**New Albany Architectural Review Board Agenda**  
Monday, December 13, 2021 7:00pm

**New Albany Architectural Review Board  
November 8, 2021 DRAFT Minutes**

## Architectural Review Board Staff Report November 8, 2021 Meeting

### CERTIFICATE OF APPROPRIATENESS & WAIVERS NEW ALBANY PRESBYTERIAN CHURCH

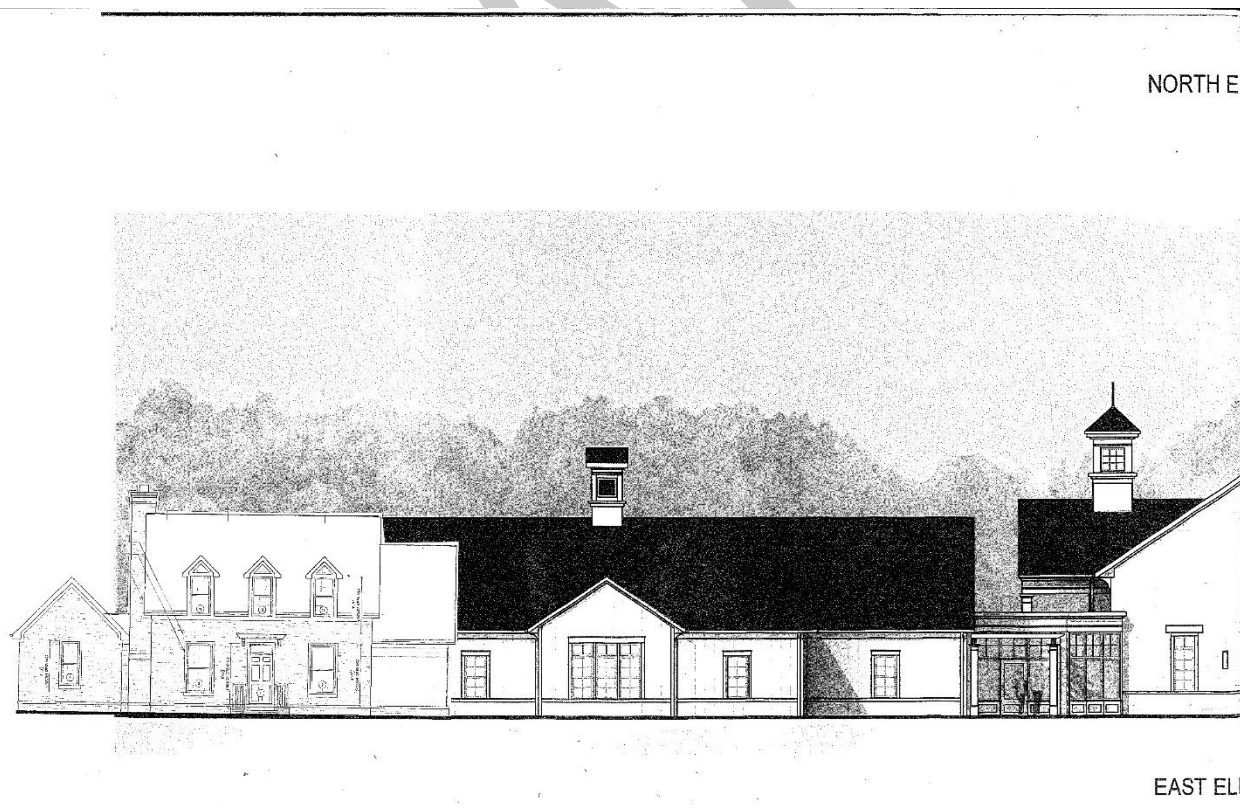
- The applicant has made the following modifications to the building architecture since the October 11<sup>th</sup> ARB hearing date based on comments made by residents and ARB members:

- The applicant increased the column width along the southern elevation of the building.
  - Enlarged pilasters were added behind each column on the southern elevation of the building.

- A stone plinth/water table was added on the entire building replacing hardi plank which was previously proposed on certain building sections.
  - The cupola on the northern elevation was shifted back to be on center with the west/east gable.

- The board-and-batten pattern was eliminated in the pediment and revised to be a smooth panel.
  - Panels were added below the large windows on the northern elevation, breaking the stone water table, to enhance the look of a front door.

- The administration wing shifted north to be on center with the narthex massing and to align with the smaller cupola in the narthex centerline.
  - The same window trim detail used on the northern elevation is now also used on the side of the sanctuary to achieve 4-sided architecture.

- The city architect has reviewed and approved all of the proposed architectural modifications to the building. These additions further enhance the quality and design of the building which accomplishes the goals and objectives of the New Albany Design Guidelines and Requirements for these types of structures.
